NEENAH PLAN COMMISSION

June 7, 2022

DATE: June 7, 2022
TO: Mayor Lang and Plan Commission
FROM: Brad Schmidt, AICP, Deputy Director
RE: Site Plan Review – 1515 S Commercial St – Car Wash

RE: Site Plan #4-22 - 1515 S Commercial St - Car Wash Site Plan - Major Review () Status Approved

SITE PLAN

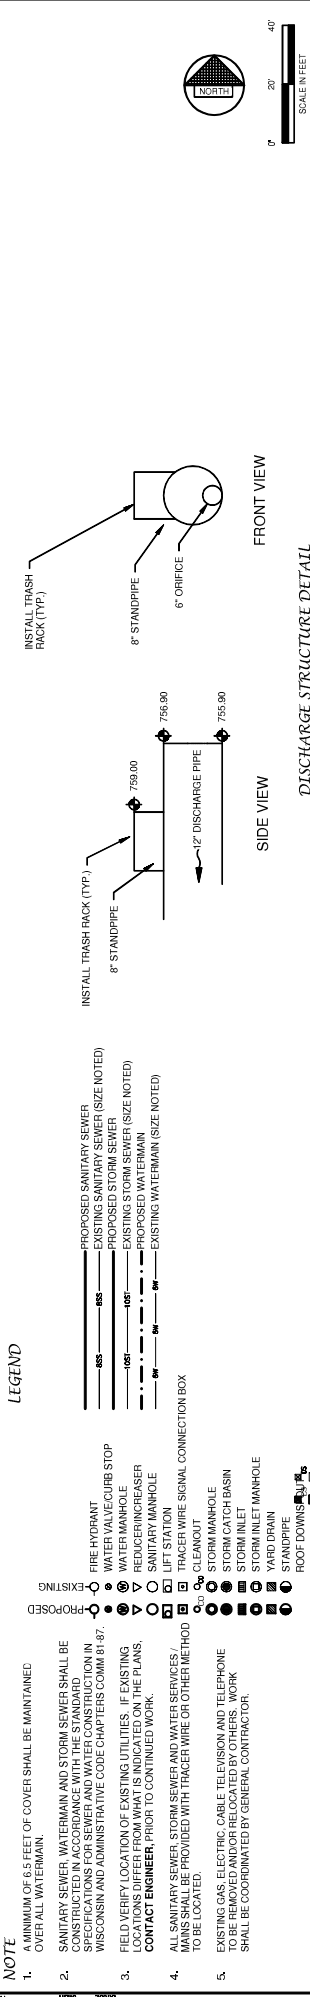
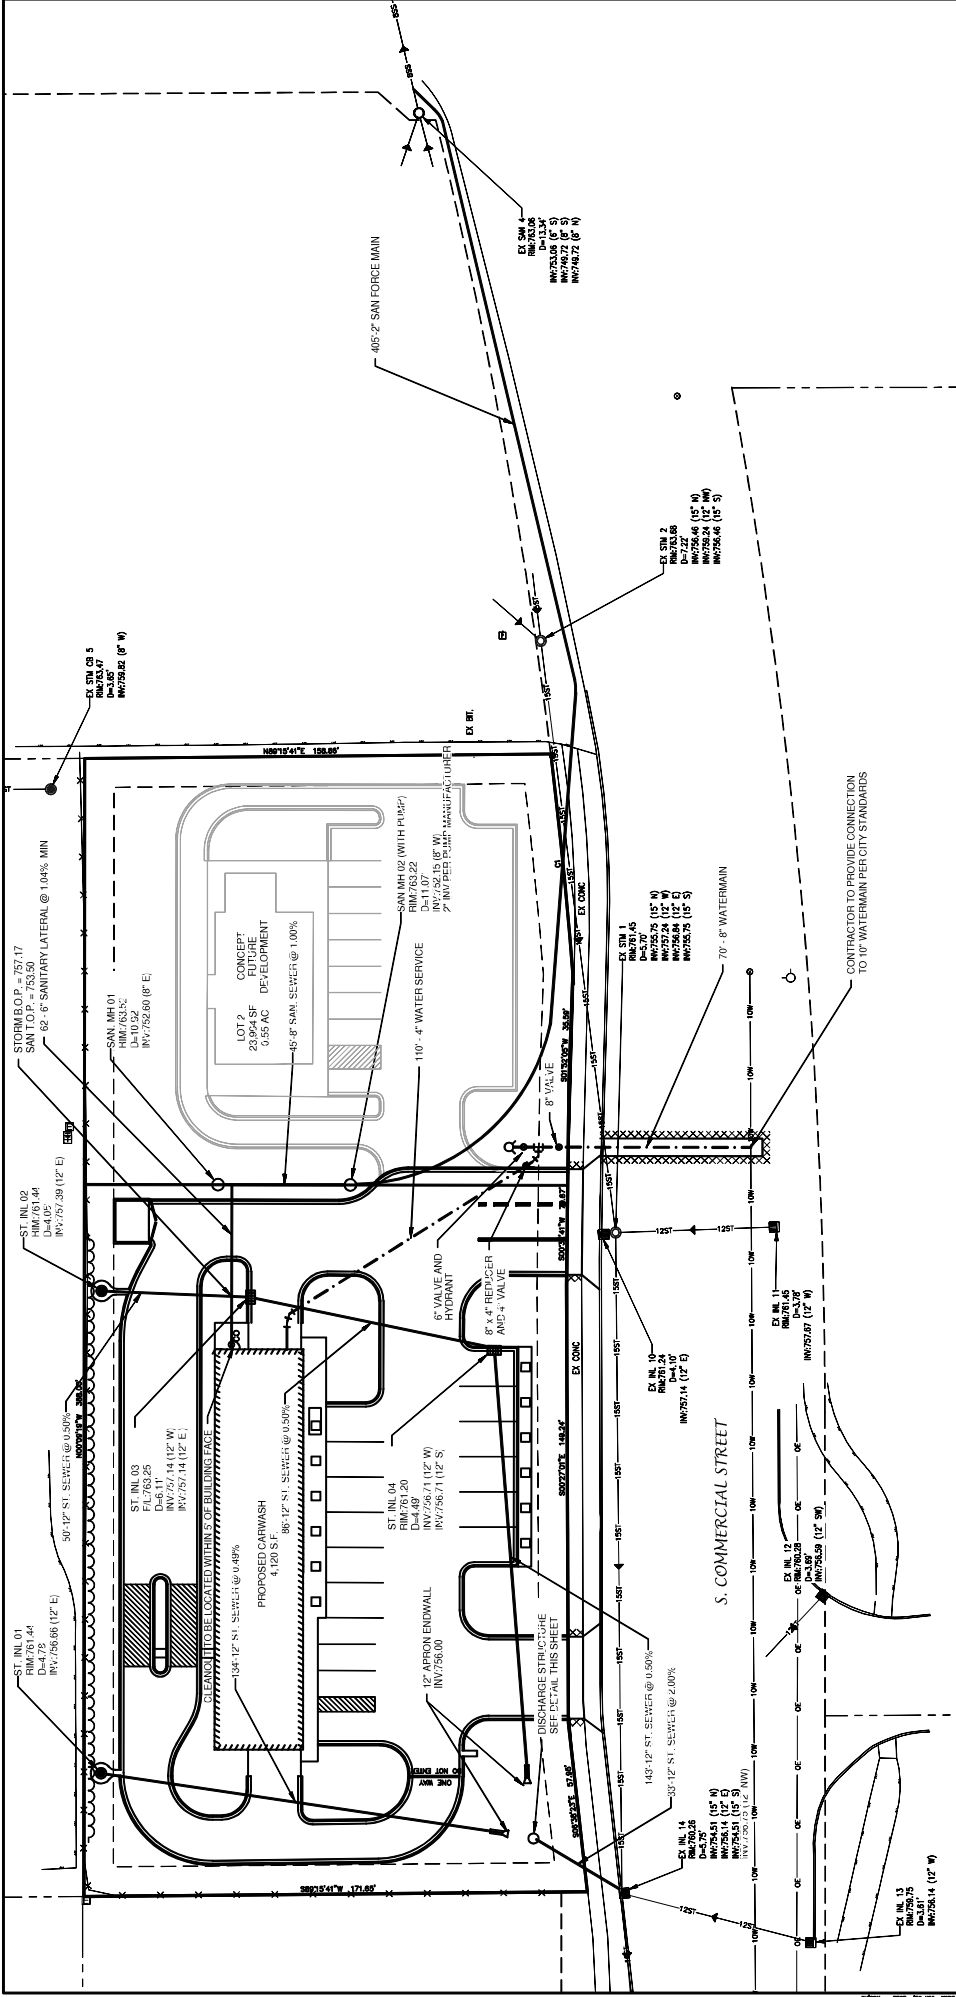
1. Prior to issuance of building or sign permits, all conditions of the site plan review must be satisfied.
2. The light intensity along the south property line adjacent to the single-family residence shall not exceed 0.0 foot-candles at the property line. A reduction of the light pole on the south property line from 20 feet to 15 feet may alleviate the light intensity at the property line.
3. The proposed north driveway must serve as a shared driveway should the lot be split in the future. If that happens, a cross access easement shall be placed on the CSM at that time. Only one driveway will be permitted for the entire development site.
4. Add an additional shade tree to the south property line. All shade trees must be a minimum of 2.5" caliper and all evergreens must be a minimum of 4 feet tall at time of planting

Remove south driveway. Only one driveway (the proposed shared north driveway) will be permitted.

LANDSCAPE PLAN

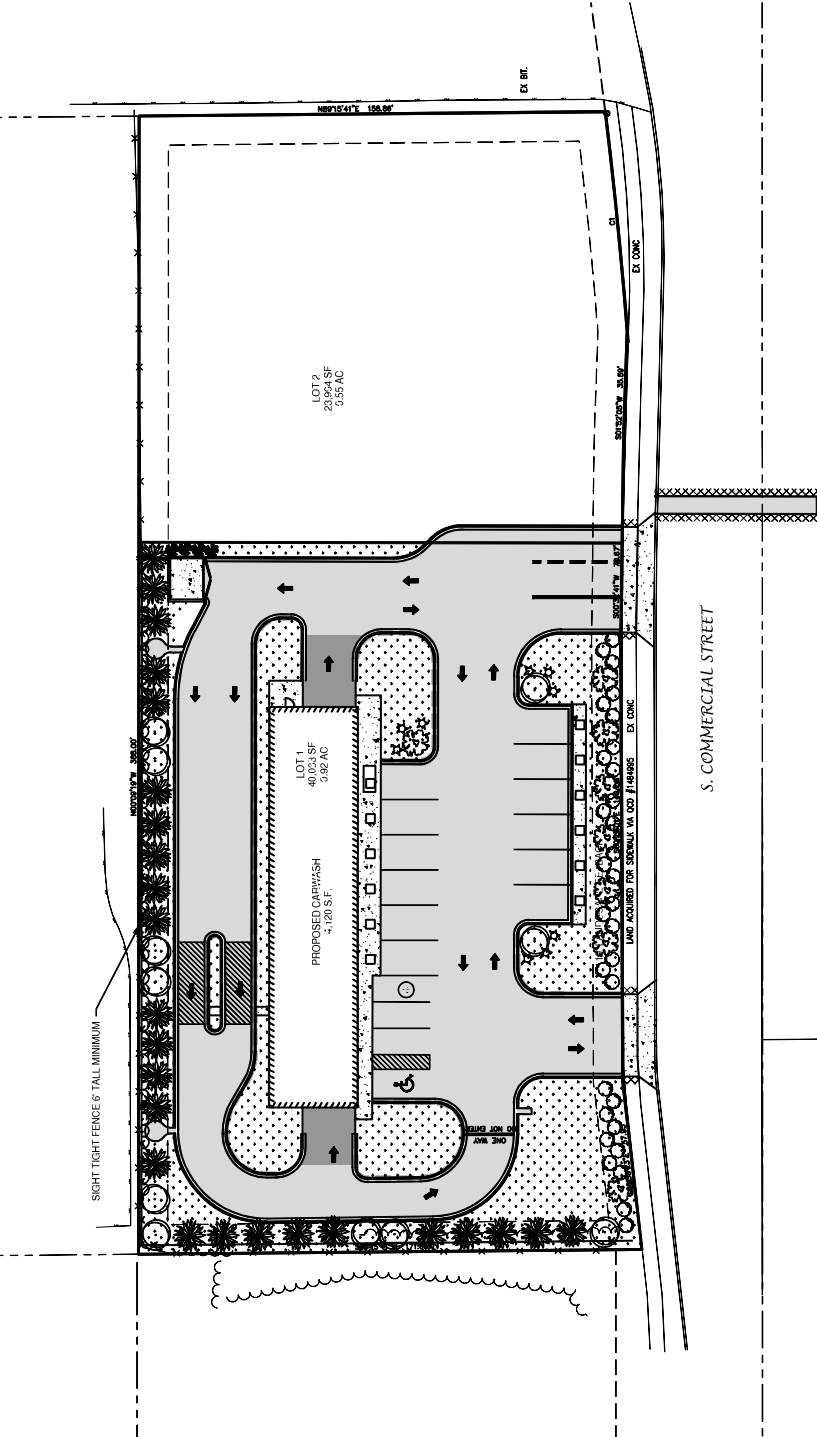
- *Add an additional shade tree to the south property line.*
- *All shade trees must be a minimum of 2.5" caliper and all evergreens must be a minimum of 4 feet tall at time of planting*
